MODIFICATION RECOMMENDED

N9913A-01

S E R V I C E N O T E

N9913A - FieldFox Handheld Analyzer

Figure 1: No sidebands issue

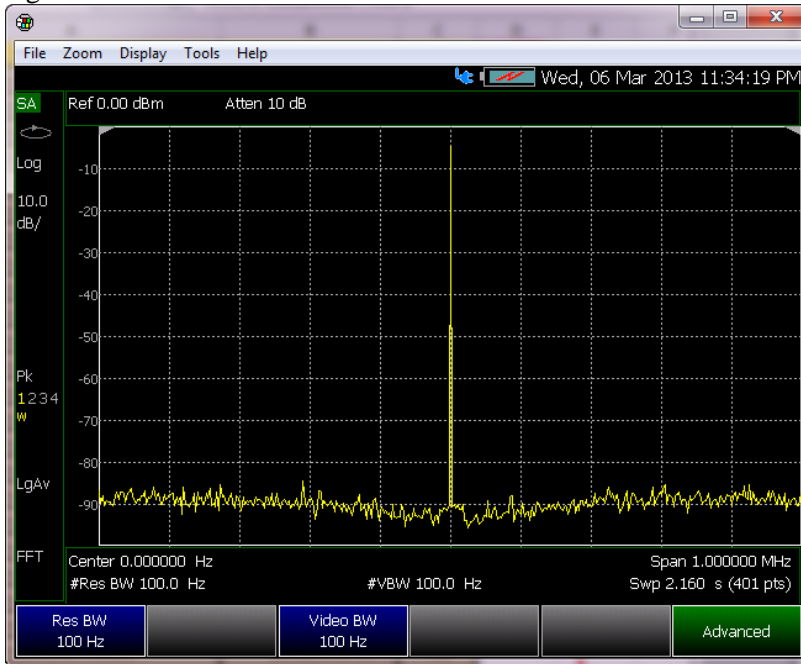
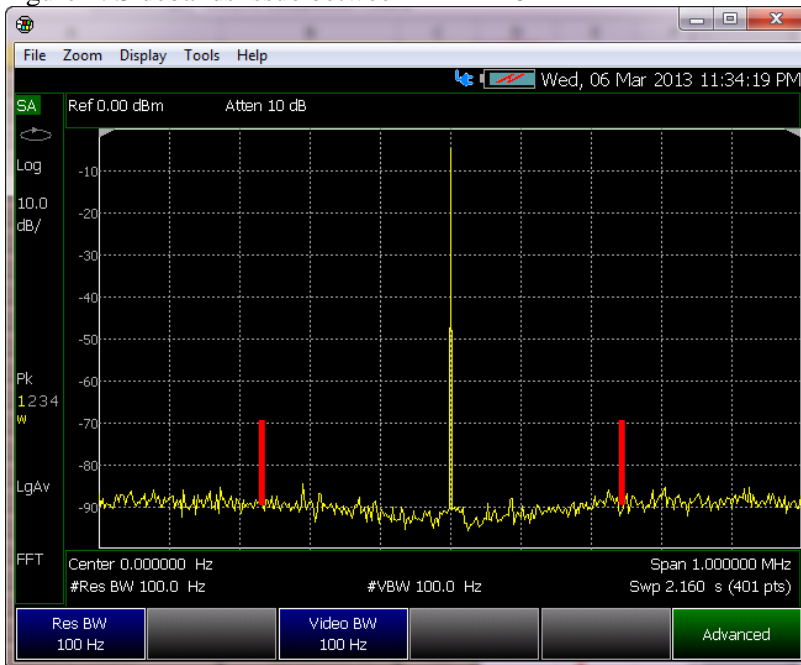
RF board earlier than Rev 7 may have sidebands issue due to oscillation by the voltage regulator. After it is fixed by replacing a new inductor, the RF board revision header will be updated to reflect the change.

Figure 1 shows a good RF signal, and Figure 2 shows FieldFox with sidebands issue.

Affected FieldFox are required to send back to Agilent factory for RF board reliability enhancement. The RF board revision header will be updated to reflect the change. Test and Adjustment shall be done before shipping back to customer.
